# UNITED STATES PATENT AND TRADEMARK OFFICE

APPLICATION NO.	FILING DATE	FIRST NAMED INVENTOR	ATTORNEY DOCKET NO.	CONFIRMATION NO.
10/623,843	07/21/2003	Veronika Polei	P2002,0618	6526
24131	7590	12/23/2004	EXAMINER	
LERNER AND GREENBERG, PA P O BOX 2480 HOLLYWOOD, FL 33022-2480			NGUYEN, KHIEM D	
			ART UNIT	PAPER NUMBER
			2823

# Office Action Summary

FIG 2b

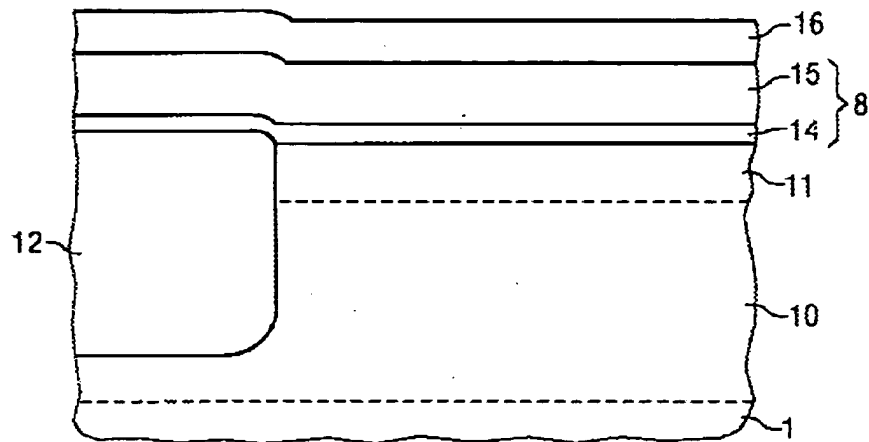
In re claim 1, Palm discloses a method for fabricating a buried bit line for a semiconductor memory, which comprises: producing strip-like doped regions parallel to and at distances from one another in a semiconductor body **1**, the regions being adapted to act as bit lines and as source/drain regions (**3, 4**) of a respective memory transistor (col. 5, line 47 to col. 6, line 19 and FIGS. 2b and 3);

FIG 3

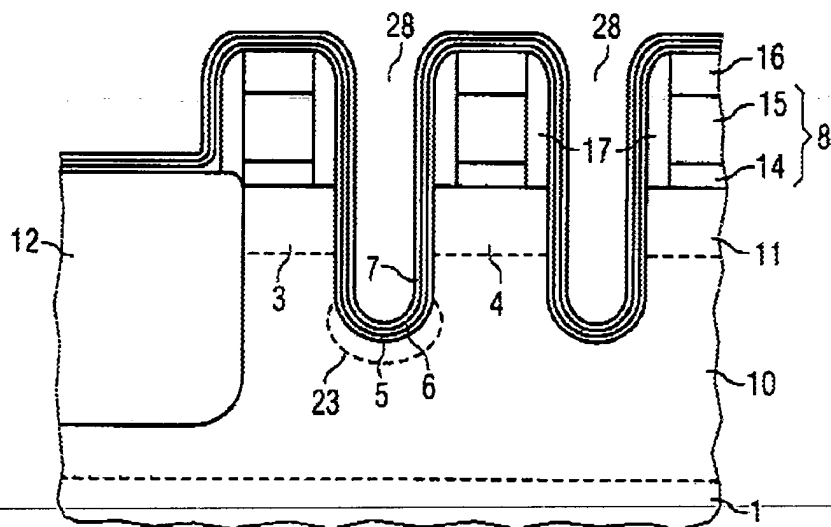
applying laterally with respect to the doped regions, in each case, one layer sequence adapted to act as a gate dielectric (ONO layer) and including a lower boundary layer 5, a storage layer 6, and an upper boundary layer 7 (col. 6, lines 20-32 and FIG. 3);

forming an oxide region in each case on a side of the doped regions remote from the semiconductor body, the oxide region being thicker than the lower boundary layer (col. 5, lines 8-46 and FIG. 3);

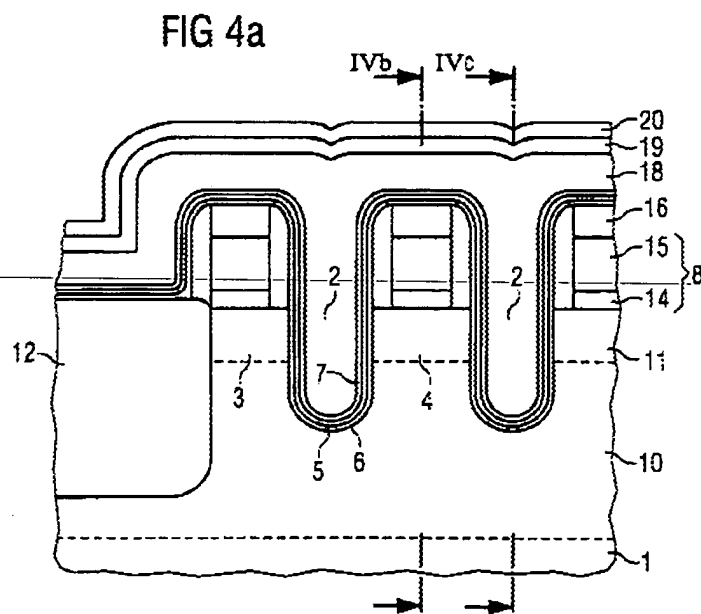
producing openings **28** in the sacrificial layer, the storage layer, and the lower boundary layer, extending the semiconductor body **1**, by using a mask (col. 5, line 60 to col. 6, line 19);

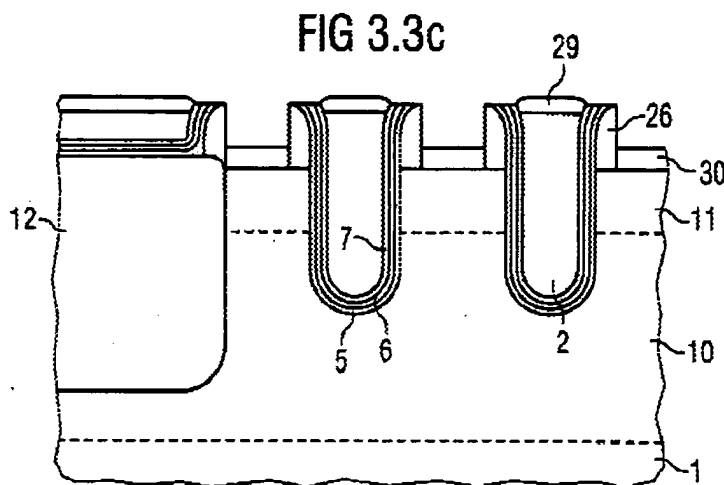
introducing doped polysilicon **18** into the openings (col. 6, lines 47-59 and FIG. 4a);
